**Re: Second Submission Review** – Green Valley Ranch East Site Plan No. 17 - Site Plan with Adjustment and Plat  
Application Number: **DA-1662-28**  
Case Number(s): 2022-4034-00; 2022-3032-00

On behalf of Oakwood Homes, Aztec Consultants, Dewberry Engineering and Terracina Design, we have reviewed the comments dated June 14, 2022. The following is a response to comments.

# GREEN VALLEY RANCH EAST FILING NO. 17 SITE PLAN

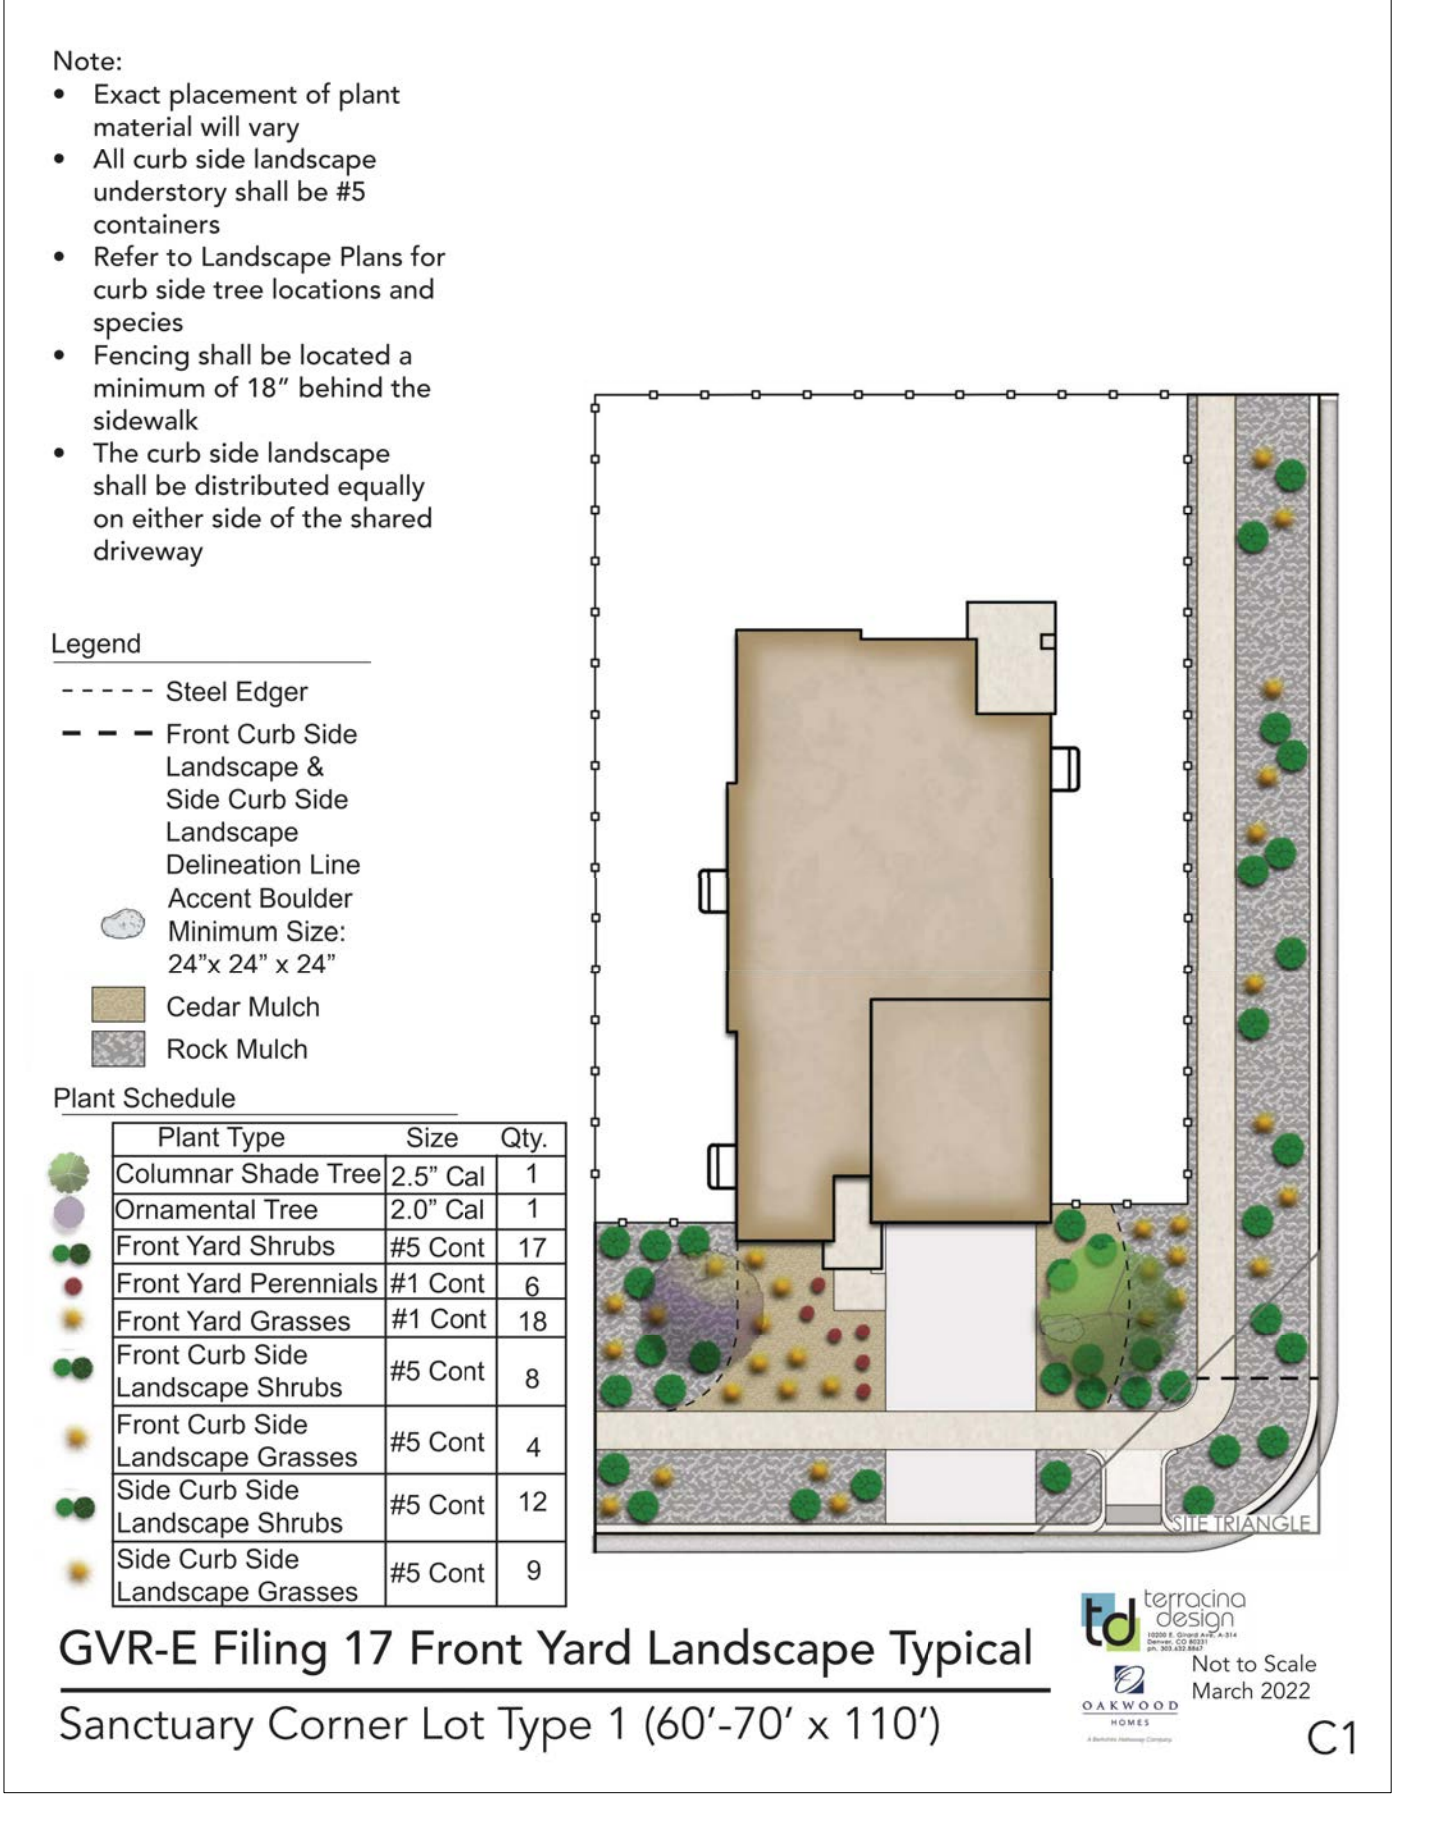
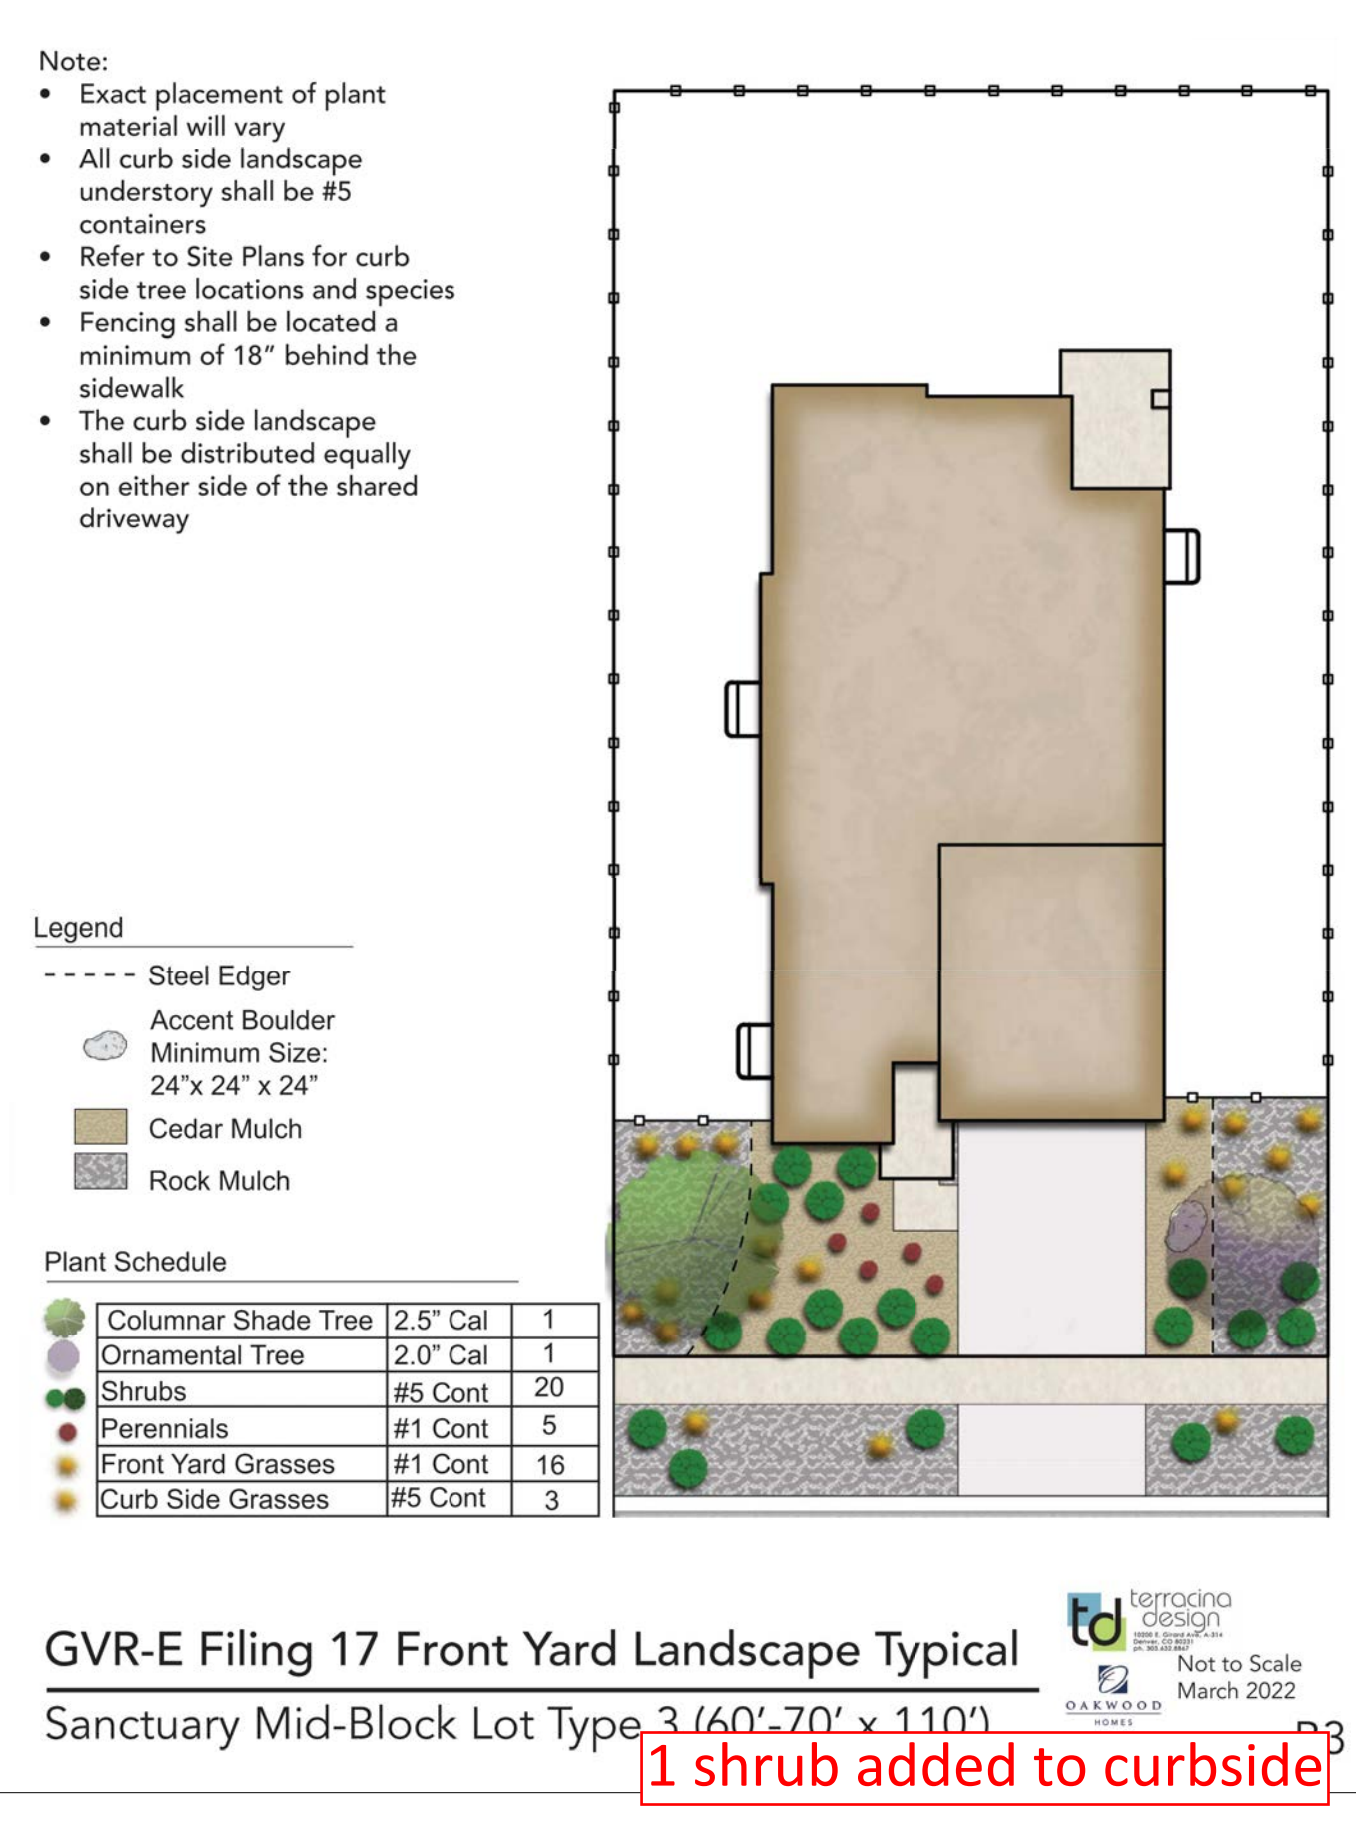
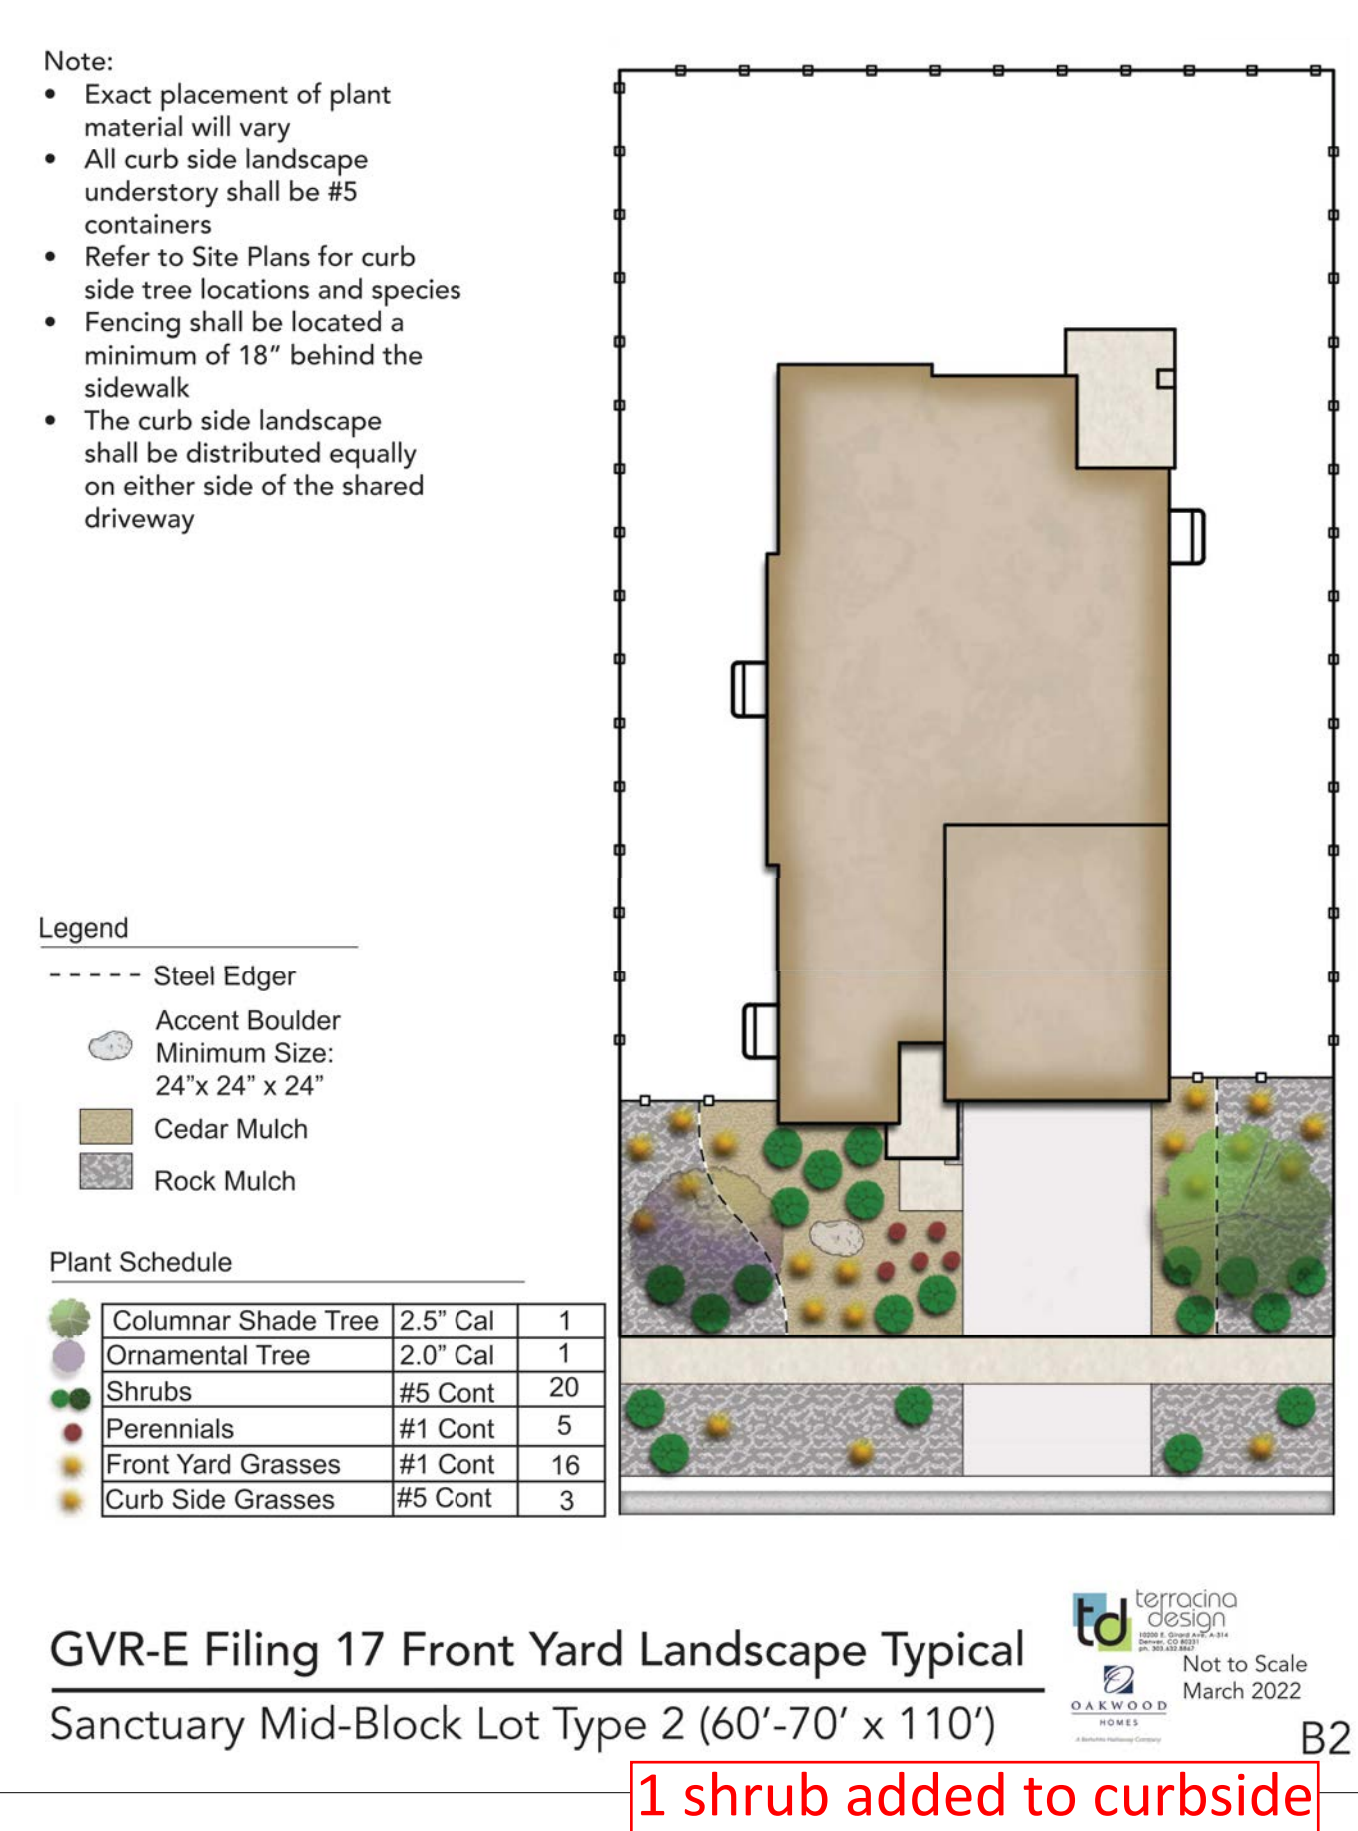
show any fencing alternatives on these plans
